# TMC SPECIFICATION

NO. S 1099

TITLE: KIT-296 -- MODIFICATION FOR LRCD & LRCB

Figure #1

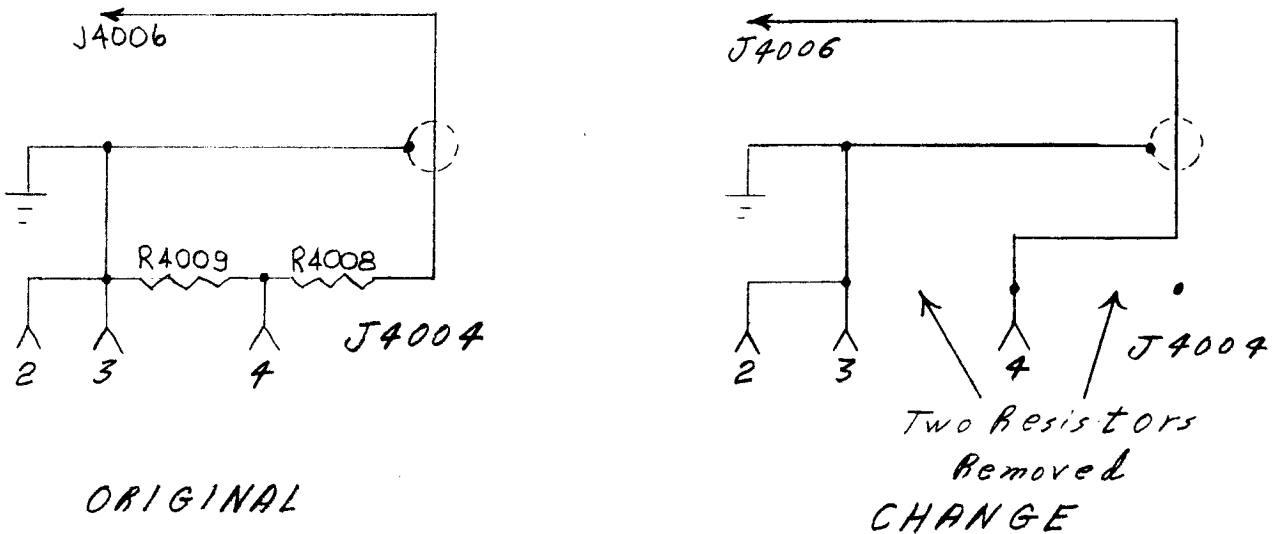
- B. Next, change AUDIO SYNC tone coax center conductor as indicated on Figure #1:

Figure #2

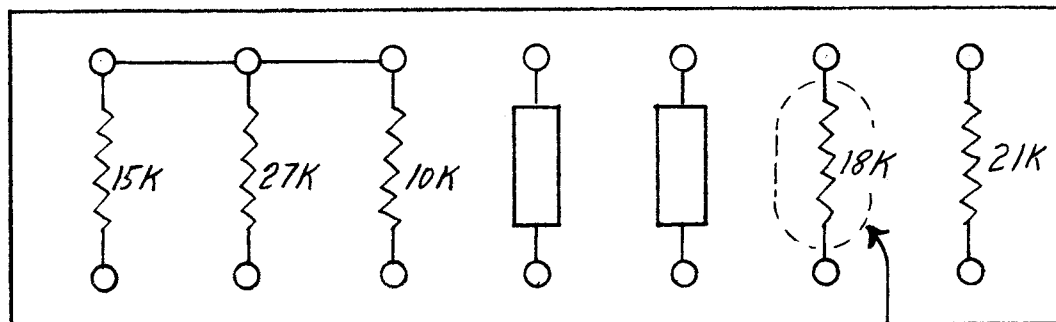
- D. Then, remove flat head 6-32 screws from bottom plate, thereby exposing the interior components.
- E. Remove capacitor(s) (nominally 33 uf) from between standoff.
- F. Your attention is now invited to the interior terminal board with components as shown below in Figure #2. Remove 18K (nominal).

*Remove By Clipping Leads*

- G. Now, remove the 18K resistor by clipping off the leads close to standoffs.
- H. On K2 relay connections, remove yellow wire pair from Pin 4 and connect yellow wire pair to standoff with grey wire pair attached. Solder a length of black insulated wire from the vacated Pin 4 to ground terminal standoff in center of box.
- I. Next, replace AZ-103 module 311 with new module 321. Fasten in place with appropriate screws. Re-install in LRCB or LRCD.
